**TO:** Sam Hubbard, Planning & Community Development  
**FROM:** Deb Pierce, Plan Reviewer, Building Services  
**DATE:** 3/23/16  
**RE:** 840 E Kensington Rd – Special Use Permit for Day Care  
**P.C. #:** 16- 007 – Round #1

To: Sam Hubbard, Planning and Community Development  
From: Cris Papierniak, Assistant Director of Public Works  
Date: April 6, 2016  
Subject: 840 E. Kensington P.C #16-007, Round 1

**PLAN COMMISSION PC #16-007**  
**Kensington School**  
**840 E. Kensington Road**  
**Special Use Permit for Day Care**  
**Round 1**

Address: Kensington School  
840 E. Kensington Road  
Special Use Permit for Day Care  
Round 1  
P.C. #16-007

Village of Arlington Heights Tower 131

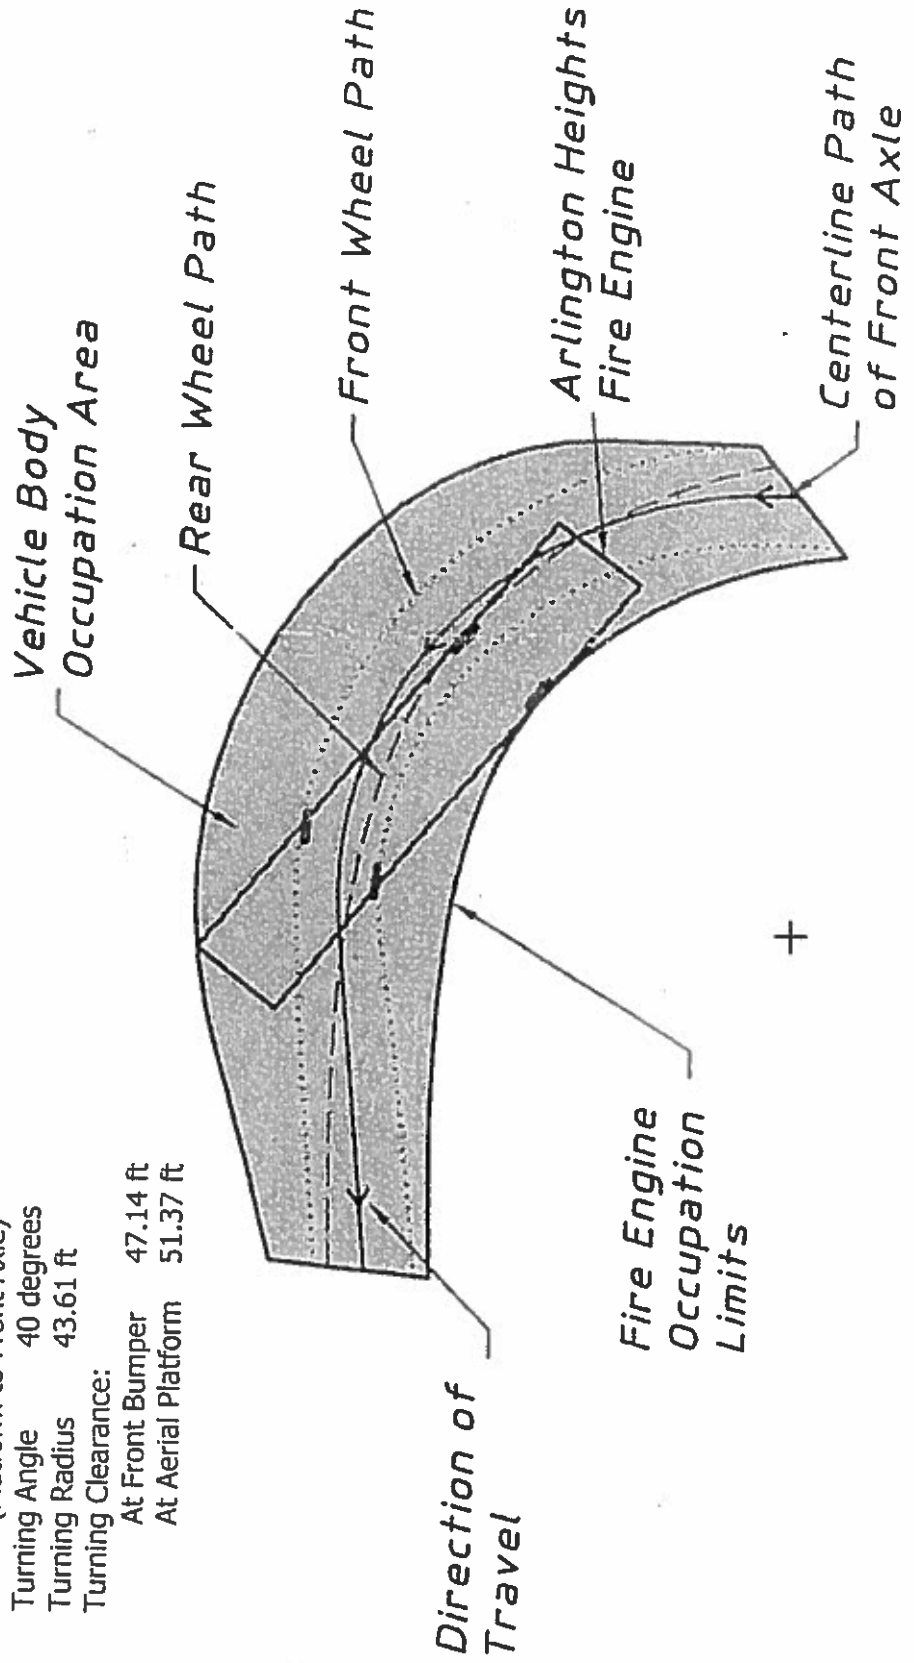
15. Provide an exhibit to engineering scale showing the turning path of the Fire Department's responding vehicle, in this case the tower truck. Exhibit must show front and rear wheel paths and the extent of the front and rear overhangs, as provided in an "Autoturn" exhibit. The vehicle shall be shown maneuvering through the site in all possible directions of travel. Attached are the specifications for the tower apparatus.
